SCI-823-0.00
PID Nos. 19415, 77366, 79977

Value Engineering Study Report
Draft Stage 2 Design Phase

re: SCI-823-0.00, PID Nos. 19415, 77366 and 79977, Portsmouth Bypass
Harrison, Jefferson, Madison and Porter Townships, Scioto County
Value Engineering Study Report

PIER DETAILS
 BRIDGE NO. SCI-823-1018 L&R
 SR823 OVER LUCASVILLE MINFORD ROAD (CR 503)

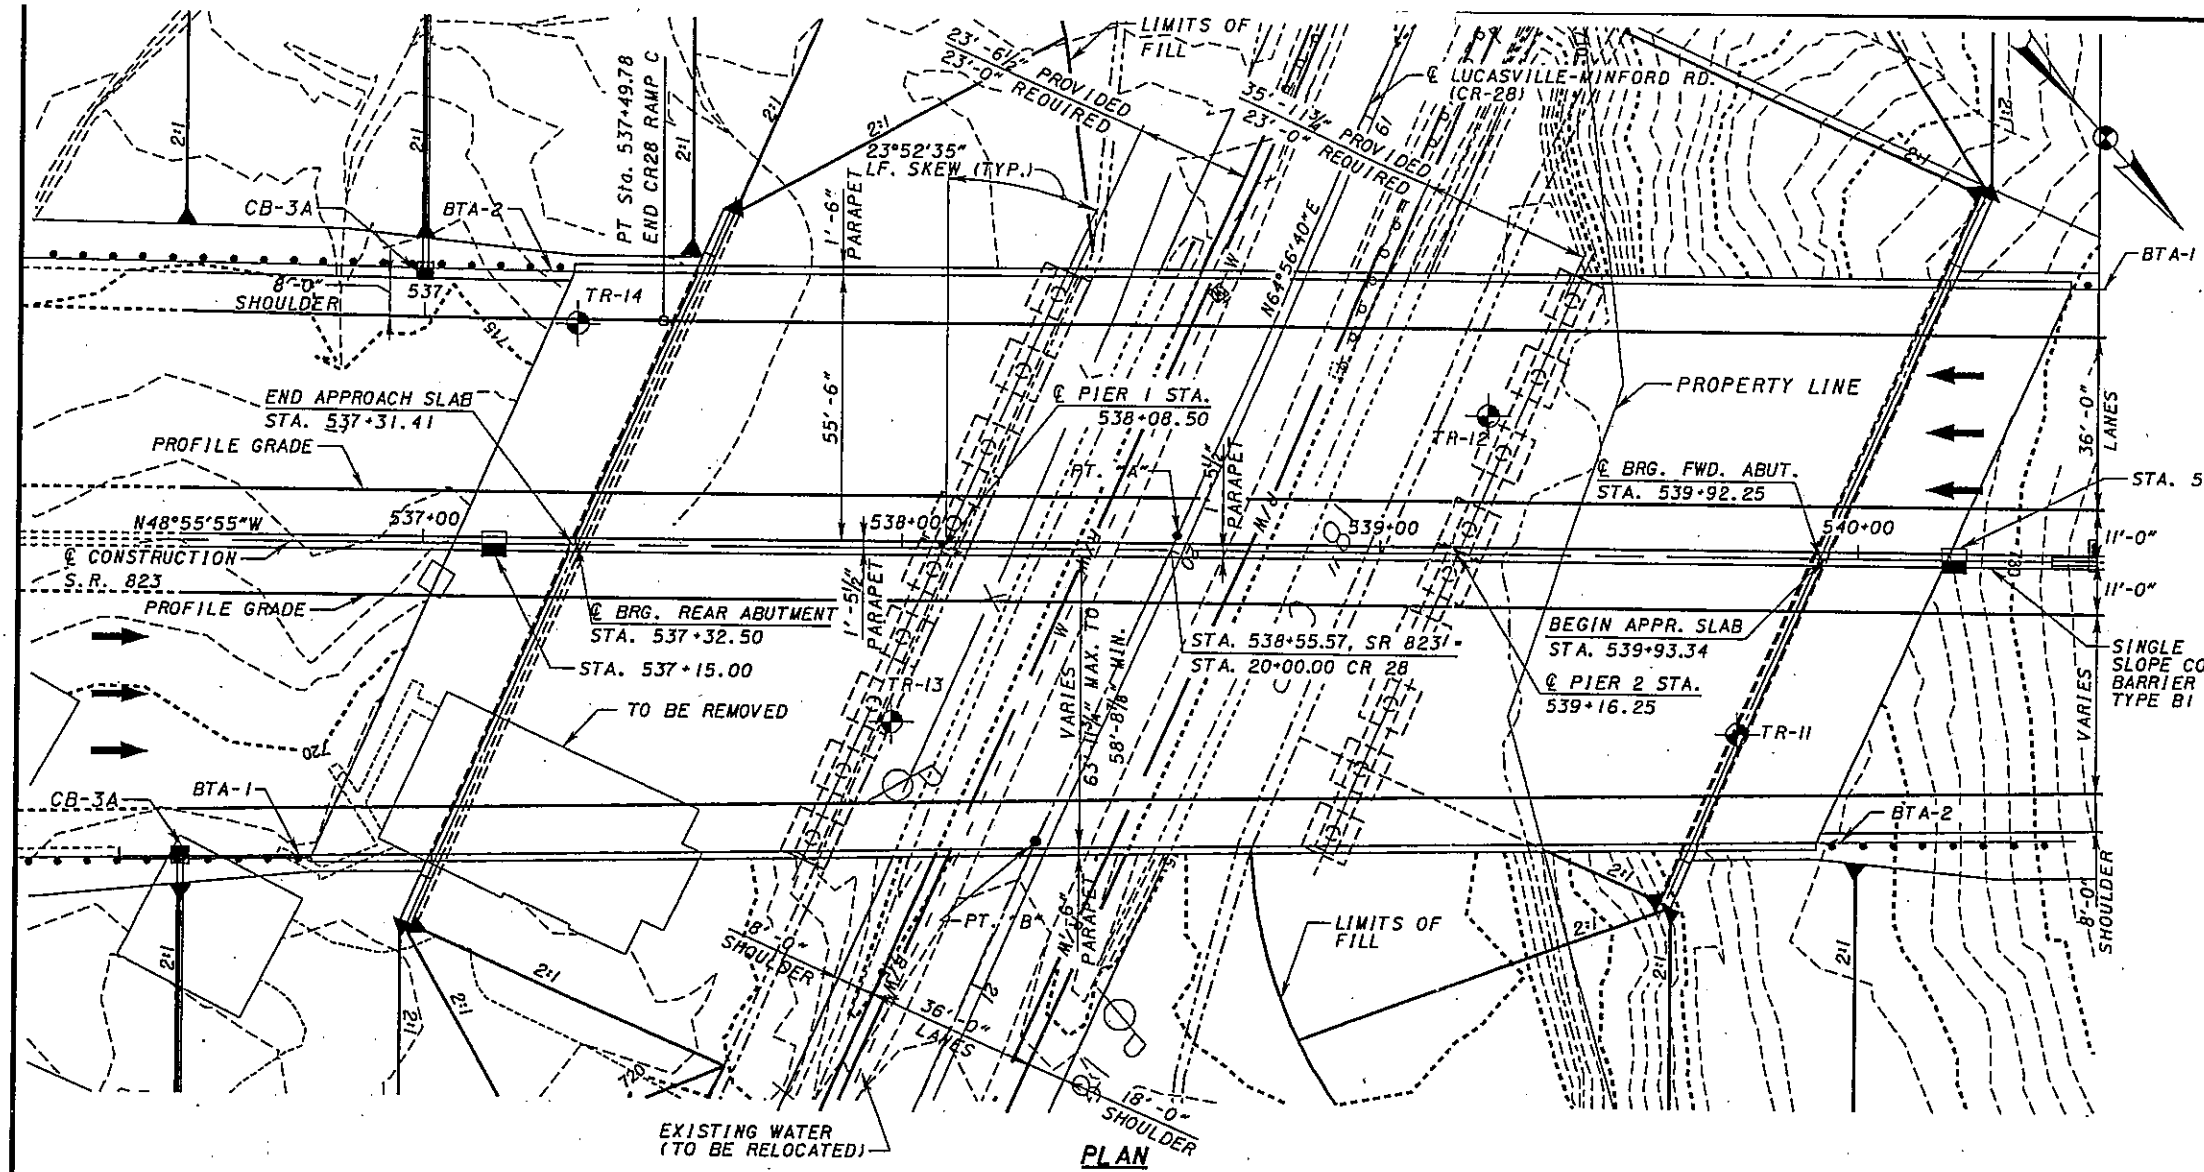
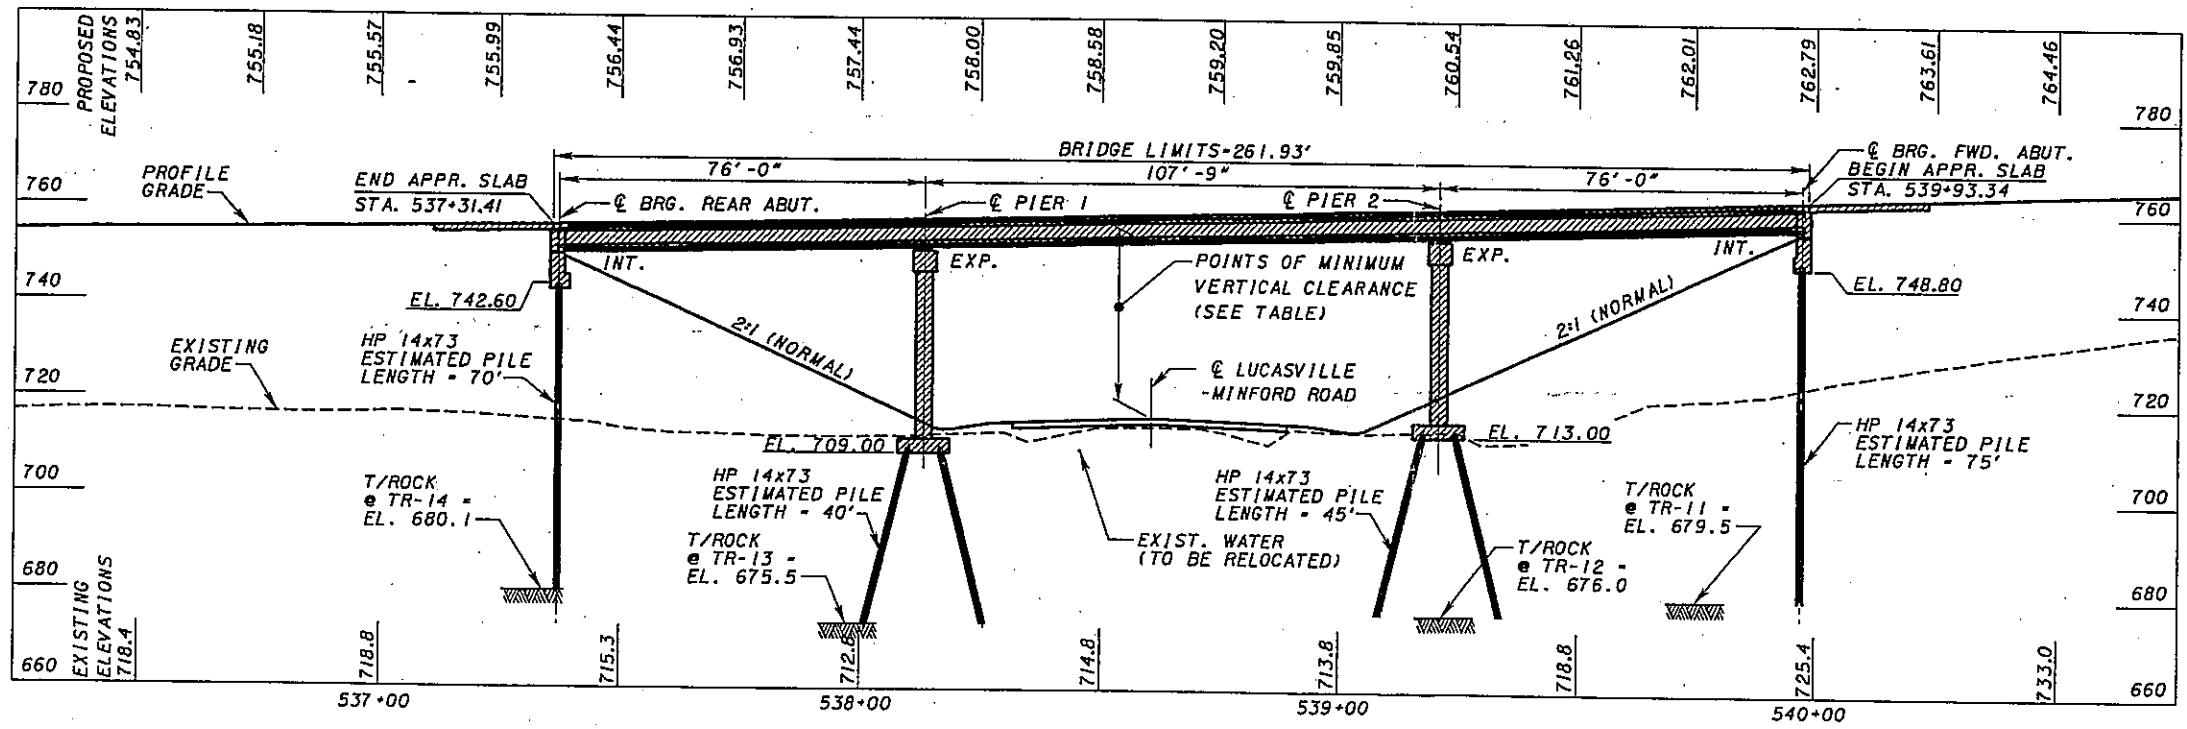
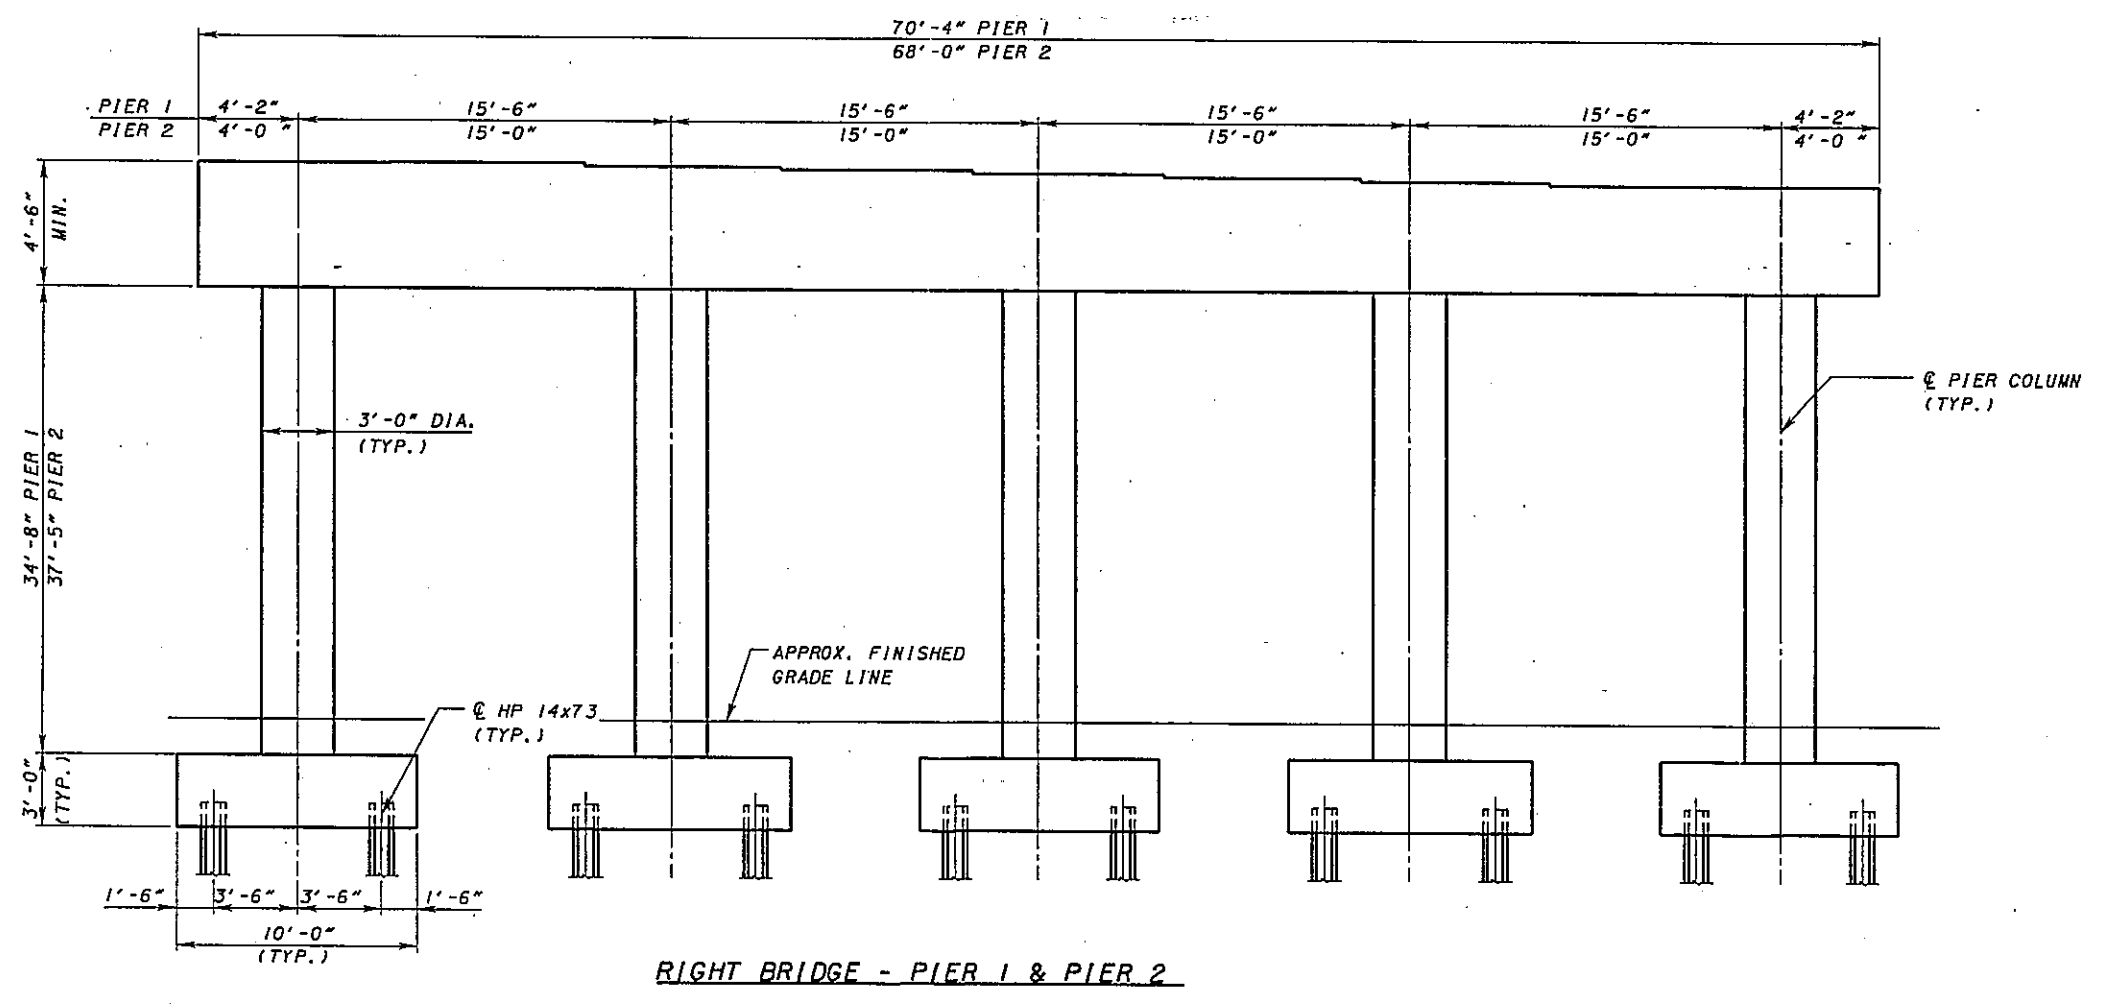
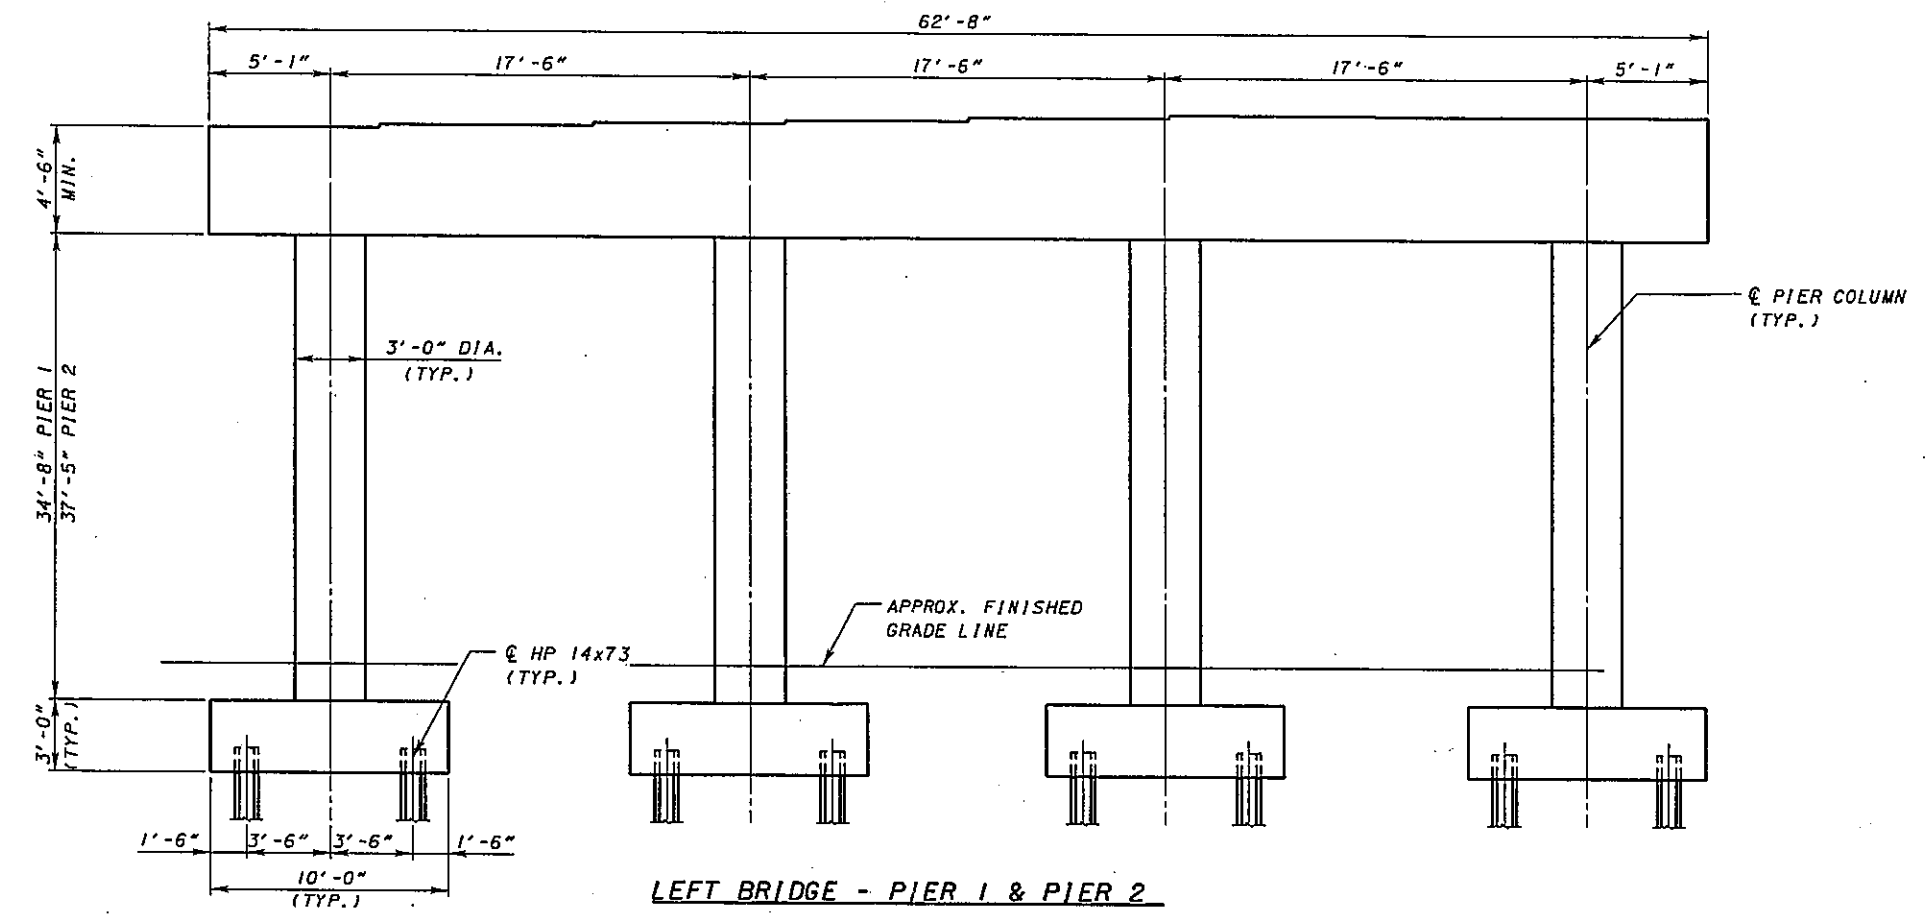
- SCI-823-1018 L&R – Site Plan
- SCI-823-1018 L&R – Pier Details
- SCI-823-1357 L&R – Site Plan
- SCI-823-1357 L&R – Pier Details

Similar change may apply to other bridges. Savings is approximately \$600,000 per bridge for the attached two example bridges.

- Revised SCI-823-1018 L&R – Site Plan
- Revised SCI-823-1018 L&R – Pier Details
- Revised SCI-823-1357 L&R – Site Plan
- Revised SCI-823-1357 L&R – Pier Details
